Access Compliance Report

Public Rights-of-Way

(Pedestrian Signals)

Intersection ID: N/A	Main Street:	Cross Street: N/A	Location: N/A
ADA ID: 4BF15EB6FBFA	Signal Type: One Push Button-Non APS	Overall Compliance: No	Severity Score: BTN 1: N/A BTN 2: N/A No BTN: N/A
Codes/Mitigation Info/Possible Solution		Field Measurements/Component Compliance

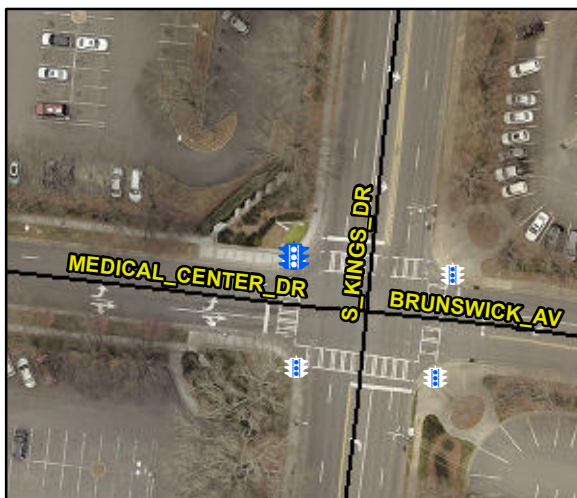
Surveyor Notes: N/A

PROW/ADA: R209.1, TMUTCD 4e.08, R404.2, R406.2

Yes	B 1 Clear Xing Direction?	ClearlyMarked	N/A	B 2 Clear Xing Direction?	N/A
	B 1 Crossing Direction	To E		B 2 Crossing Direction	N/A
Yes	B 1 DistanceTo XWalk (in)	0.0	N/A	B 2 DistanceTo XWalk (in)	N/A
No	B 1 DistanceTo Curb (in)	96.0	N/A	B 2 DistanceTo Curb (in)	N/A
Yes	B 1 Diameter (in)	2.0	N/A	B 2 Diameter (in)	N/A

Possible Solutions: Replace Signal Push Button With APS Button on New Post.
